# UNITED STATES PATENT AND TRADEMARK OFFICE

APPLICATION NO.	FILING DATE	FIRST NAMED INVENTOR	ATTORNEY DOCKET NO.	CONFIRMATION NO.
10/628,968	07/28/2003	Michael Thomas Krawczyk	Aqua Lung.1466	6187
27547	7590	11/01/2004	EXAMINER	
MURPHEY & MURPHEY, A.P.C. 701 PALOMAR AIRPORT ROAD, SUITE 260 CARLSBAD, CA 92009			MITCHELL, TEENA KAY	
			ART UNIT	PAPER NUMBER
			3743

# Office Action Summary

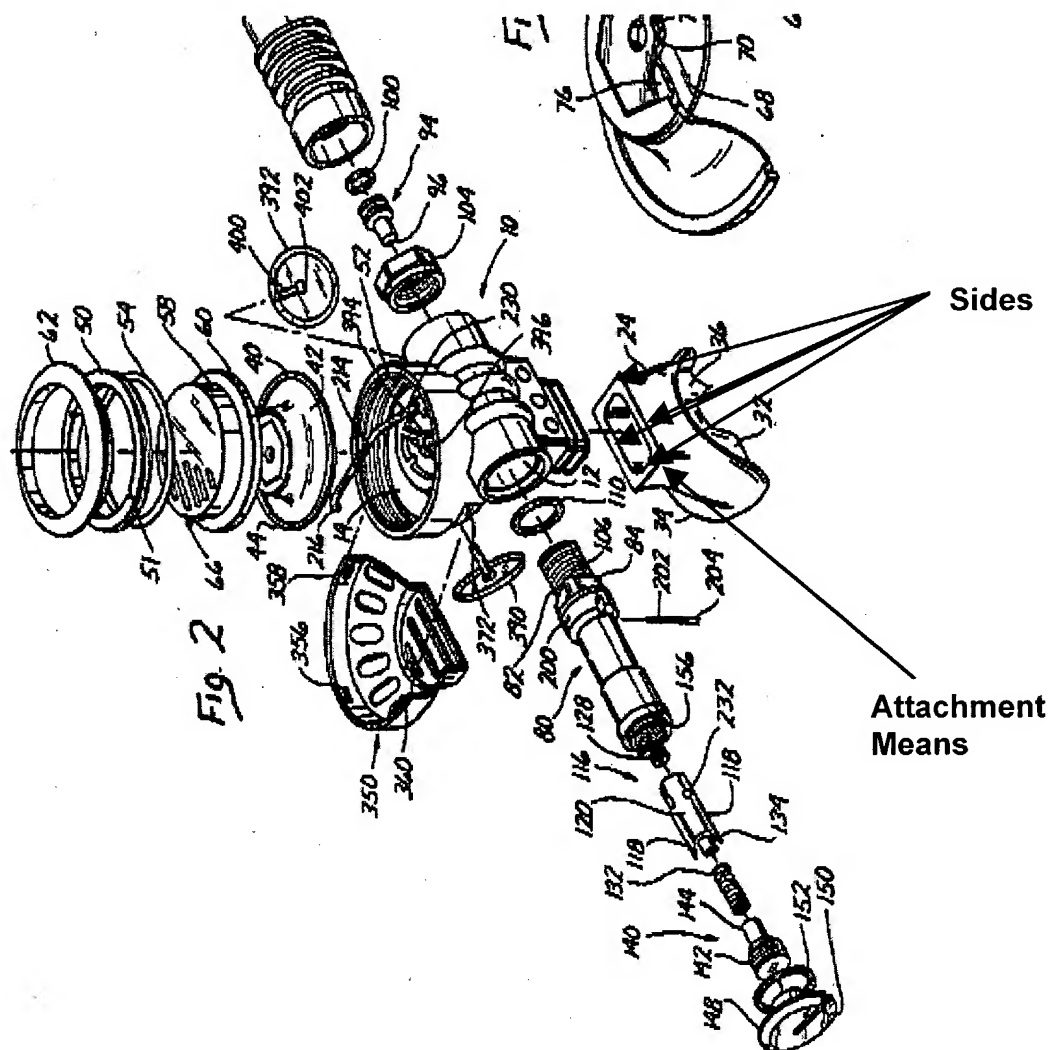
Winefordner in a regulator discloses:

- a chamber having a cylindrical body (10);
- a first opening on the cylindrical body (14) wherein an exhaust valve (40) is removably attached to the first opening of the cylindrical body;
- a second opening on the cylindrical body (note #24; opening where 24 inserts into the body) wherein a mouthpiece (24) is removably attached to the second opening of the cylindrical body;
- a hose (at 104) connected to the chamber wherein the hose connects the cylindrical body to an air source.

With respect to claim 5, the mouthpiece has an attachment means with a plurality of sides for attachment to the regulator (see illustration of Fig. 2 below).
